▶ Change on Foot

▶ BO4553, BO4554, BO4561

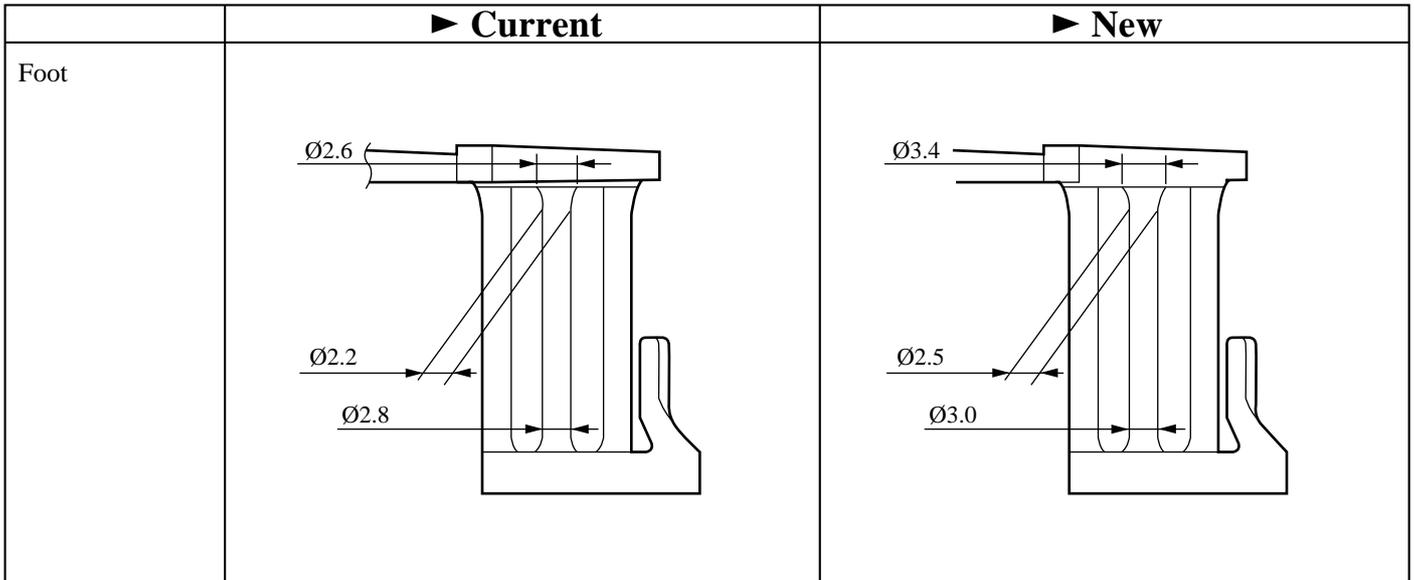
▶ As illustrated below, thickness of poles of Foot has been increased for improvement in endurance.

Item No.	Current part	Q'ty	New part	Q'ty	I/C	Note
15	Foot 414312-9	2	Foot 410918-1	2	<=
